QUALITY ASSURANCE -- NON-CONFORMANCE REPORT

Location: Changxing Island, Shanghai, P.R. China **Report No:** NCR-000936
Prime Contractor: American Bridge/Fluor Enterprises, a JV **Date:** 10-Dec-2010
Submitting Contractor: Zhenhua Port Machinery Company, Ltd (ZPMC), Changxing Island **NCR #:** ZPMC-0897

Reference Description: West Tower Cover Plates Re-installed without following Approved Shop Drawing

Job Name: SAS Superstructure

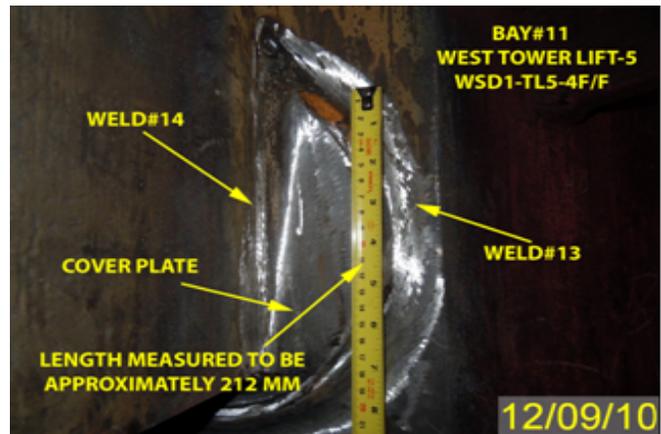
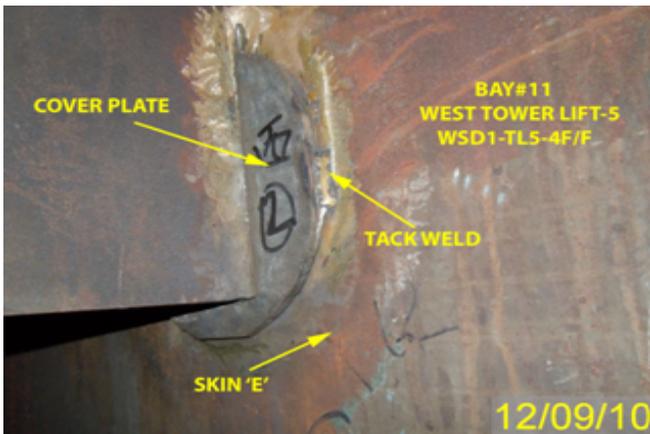
- ZPMC fabrication personnel removed 2 cover plates involving a total four (4) Non-SPCM fillet welds without notifying the Engineer .
- ZPMC re-welded with new cover plates, where the dimensions of the cover plates do not comply with the approved drawings.
- As per the shop drawing the required length of the cover plate is 151.4 mm. The length measured was approximately 212 mm.
- Welds are fillet welds joining cover plate to skin 'E'.
- The weld designations are WSD1-TL5-4F/F#13; 14; 15; 16.
- This component located at fabrication Bay#11.
- NCR ZPMC-827 had been issued on 10/19/2010 for the two non-conforming cover plates that were removed. Response to this NCR is still outstanding today.

Contractor will submit revised shop drawing as per the as built for Engineer's approval. Ensure in future to communicate with CT before any modification works are performed.

Contractor has revised the shop drawing and submitted for Engineer's approval. The revised drawing has been accepted and the cover plate left as- built.

Reference Description: Lift 5: North Grillage Cover Plate dimension for Longitudinal Grillage plate do not match with Drawing

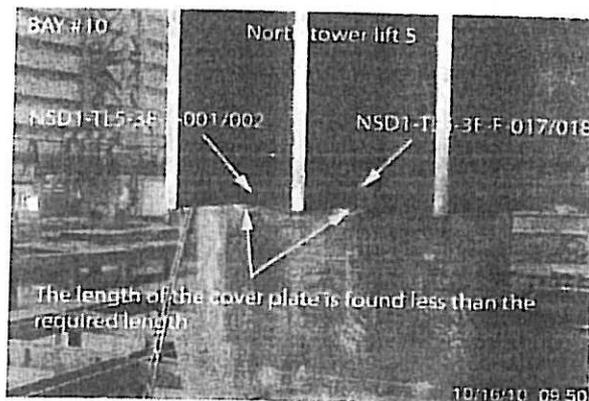
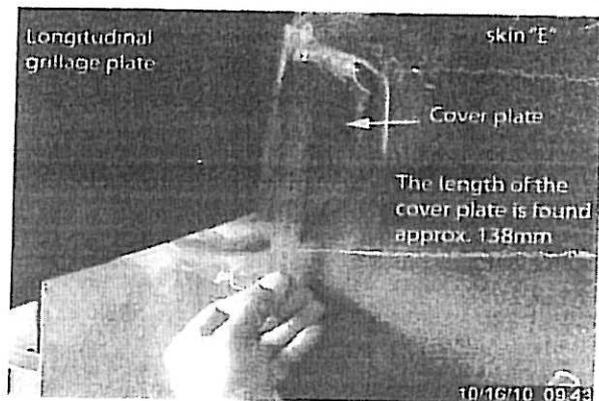
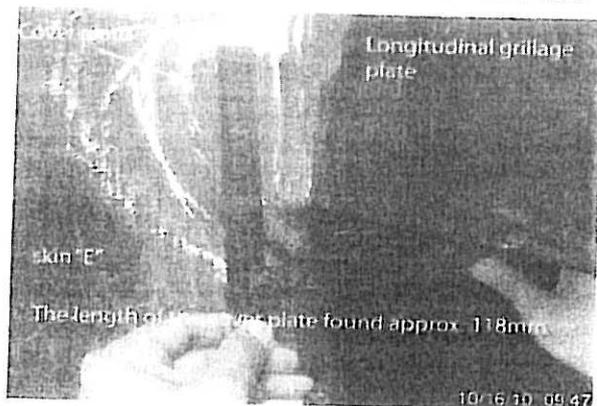
- The dimensions of Cover Plate do not match the approved shop drawings.
- As per shop drawing the required length of the Cover Plate is 151.4mm.
- Cover Plate weld # NSD1-TL5-3E/F-001/002, the length of the Cover Plate was measured as 138mm.
- Cover Plate weld # NSD1-TL5-3E/F-017/018, the length of the Cover Plate was measured as 118mm and 143mm.
- These welds are fillet welds, joining the Cover Plate to the Skin Plate and Longitudinal Grillage plate.
- The member is located in Bay 10.

Reference Description: North Tower Lift 5 Cover Plate Re-Installed Not in accordance to Approved Shop Drawing

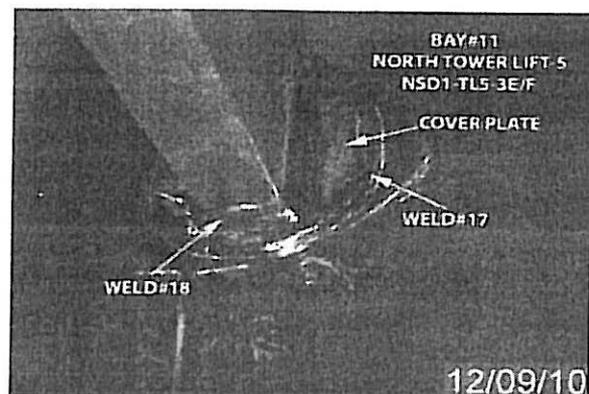
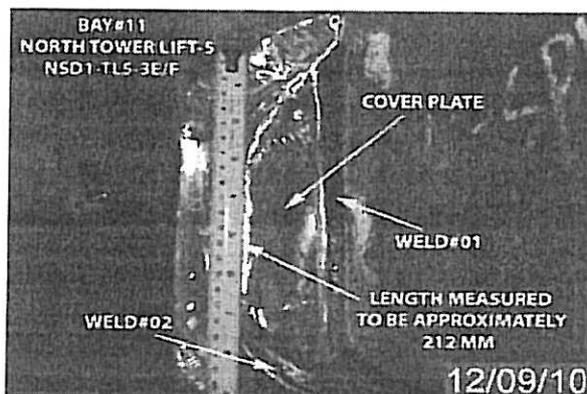
- ZPMC fabrication personnel removed 2 cover plates involving a total four (4) Non-SPCM fillet welds without notifying the Engineer .
- ZPMC re-welded with new cover plates, where the dimension of the cover plates does not comply with the approved drawings.
- As per the shop drawing the required length of the cover plate is 151.4 mm. The length measured was approximately 212 mm.
- Welds are fillet welds joining cover plate to skin 'E'.
- The weld designations are NSD1-TL5-3E/F#01; 02; 17; 18.
- This component located at fabrication Bay#11.
- NCR ZPMC-827 had been issued on 10/19/2010 for the two non-conforming cover plates that were removed. Response to this NCR is still outstanding todate.

Reference Description: West Tower Cover Plates Re-installed without following Approved Shop Drawing

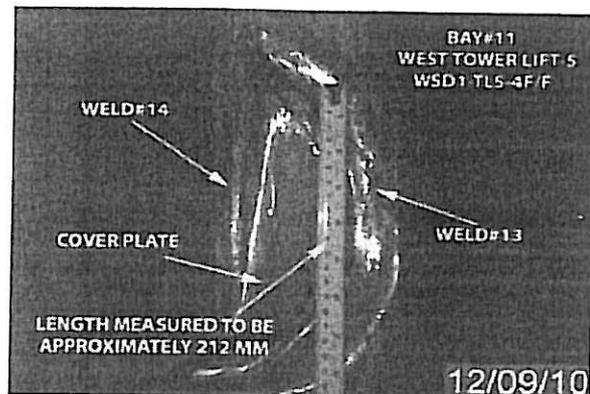
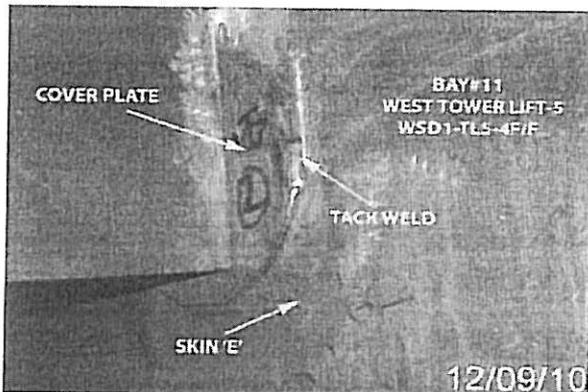
- ZPMC fabrication personnel removed 2 cover plates involving a total four (4) Non-SPCM fillet welds without notifying the Engineer.
- ZPMC re-welded with new cover plates, where the dimensions of the cover plates do not comply with the approved drawings.
- As per the shop drawing the required length of the cover plate is 151.4 mm. The length measured was approximately 212 mm.
- Welds are fillet welds joining cover plate to skin 'E'.
- The weld designations are WSD1-TL5-4F/F#13; 14; 15; 16.
- This component located at fabrication Bay#11.
- NCR ZPMC-827 had been issued on 10/19/2010 for the two non-conforming cover plates that were removed. Response to this NCR is still outstanding today.

A5-1 - PL 10X190X 212.5 (A709M-345 T2)

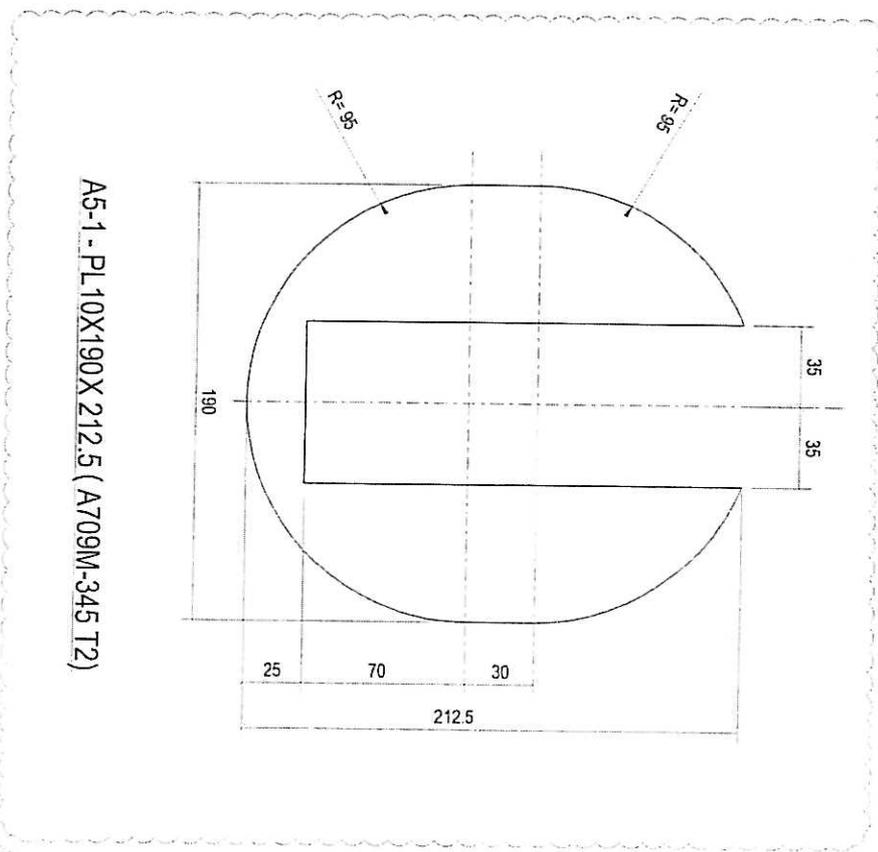
Here we clarify as below, as ZPMC got the oral agreement "RFF" drawing, so it was thought can be used without submitting formal documentation, but actually it should be. So it was a misapprehension, in the future we will take more care and make more communication with each other to avoid such problem. As a result the drawing was approved by Engineer and welds were accepted and green tagged.

Reference Description: West Tower Cover Plates Re-installed without following Approved Shop Drawing

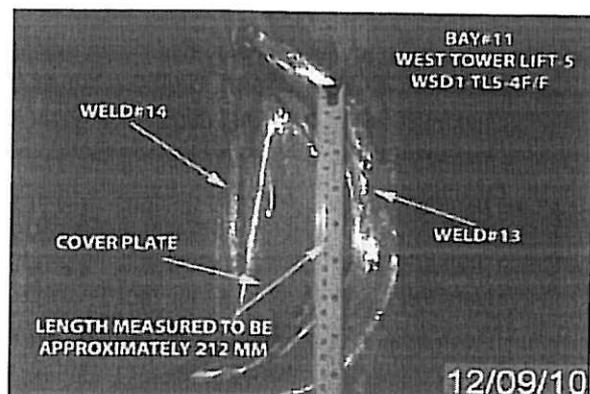
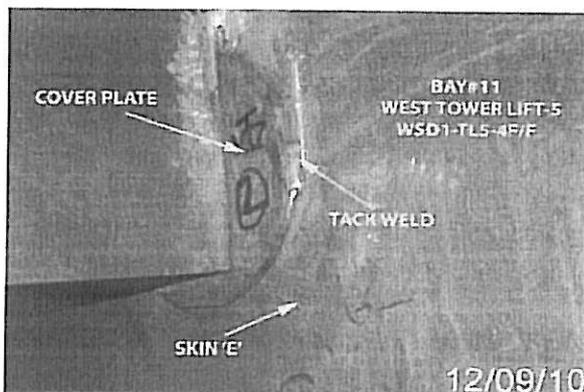
- ZPMC fabrication personnel removed 2 cover plates involving a total four (4) Non-SPCM fillet welds without notifying the Engineer.
- ZPMC re-welded with new cover plates, where the dimensions of the cover plates do not comply with the approved drawings.
- As per the shop drawing the required length of the cover plate is 151.4 mm. The length measured was approximately 212 mm.
- Welds are fillet welds joining cover plate to skin 'E'.
- The weld designations are WSD1-TL5-4F/F#13; 14; 15; 16.
- This component located at fabrication Bay#11.
- NCR ZPMC-827 had been issued on 10/19/2010 for the two non-conforming cover plates that were removed. Response to this NCR is still outstanding today.
